**HARVEY LYON - INTERROGATORY #1**

Filed: January 16, 2012  
EB-2012-0365  
Exhibit B  
Tab 1  
Schedule 3  
Responses to Harvey  
Lyon Interrogatories  
Appendix A

**APPENDIX A**  
**REVISED MAP**

# Dufferin Wind Power Project

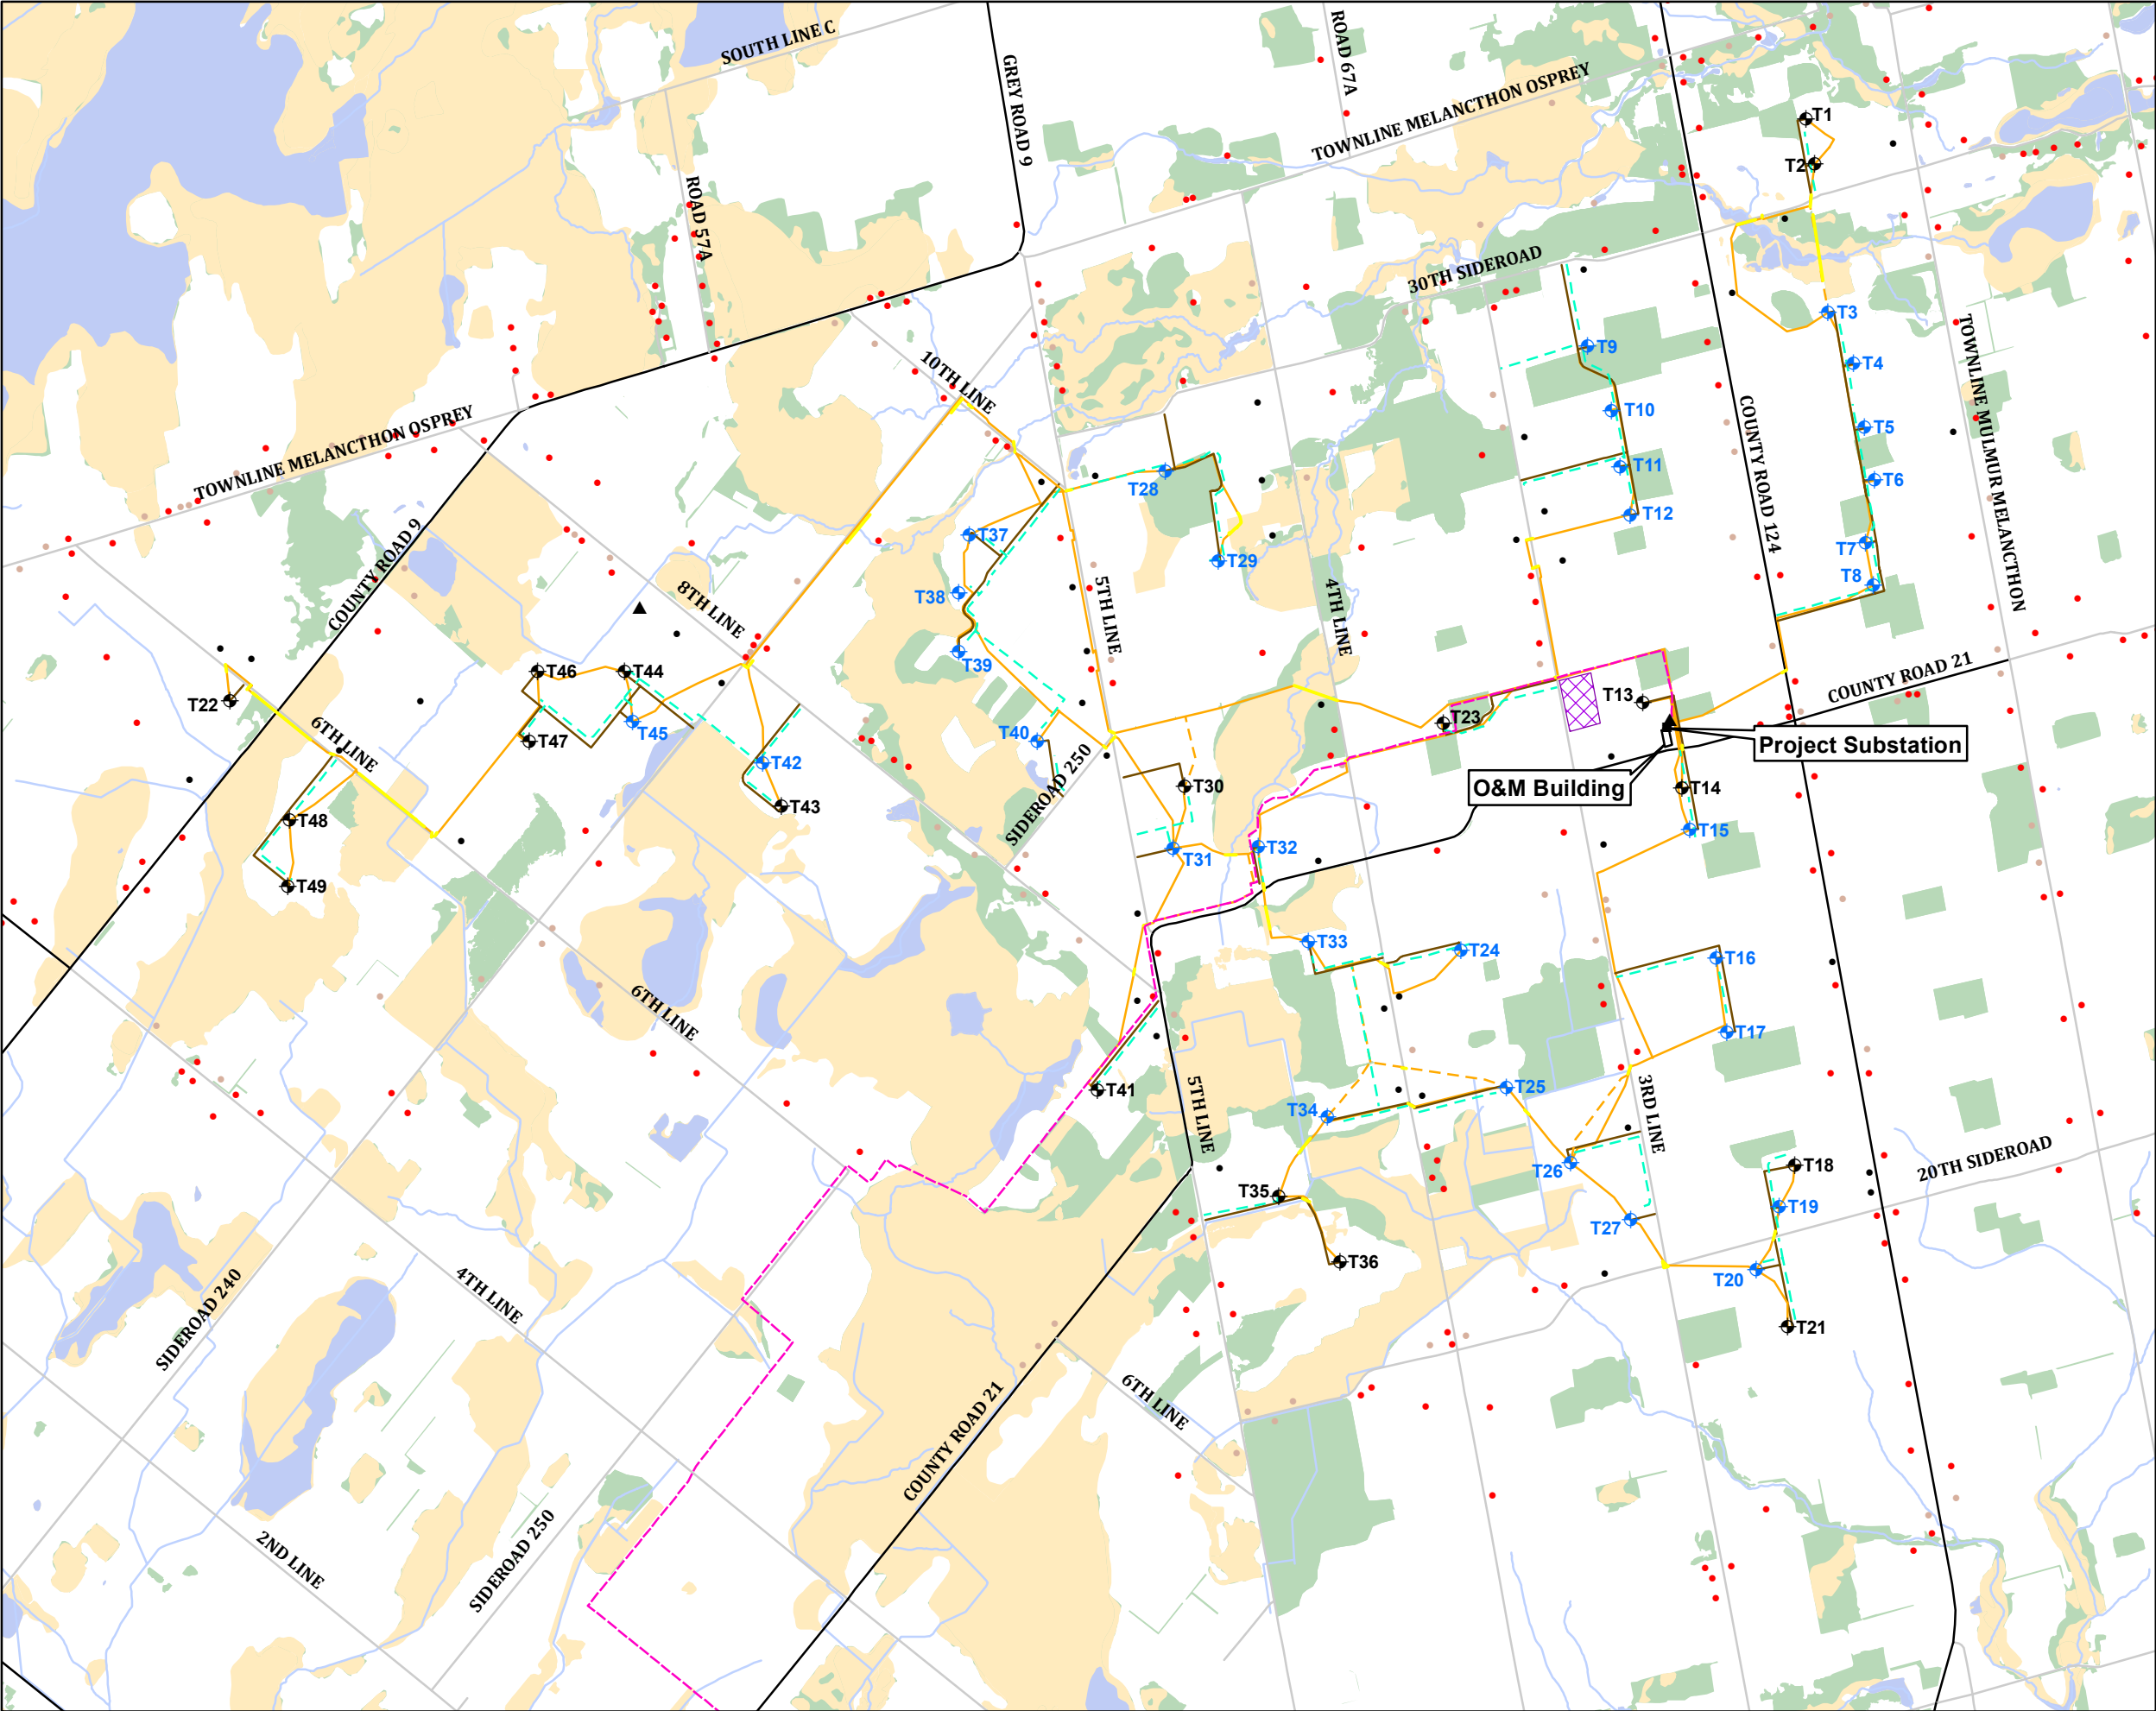
- a. There are far too many 250 sideroads going in contrary directions (Fig 1, Fig 4 ...). This error has previously been pointed out at the PICs. Although those knowledgeable with the area can likely sort it out, I request that the errors be corrected.

- a. This comment has been noted and a revised map is provided in Appendix A.
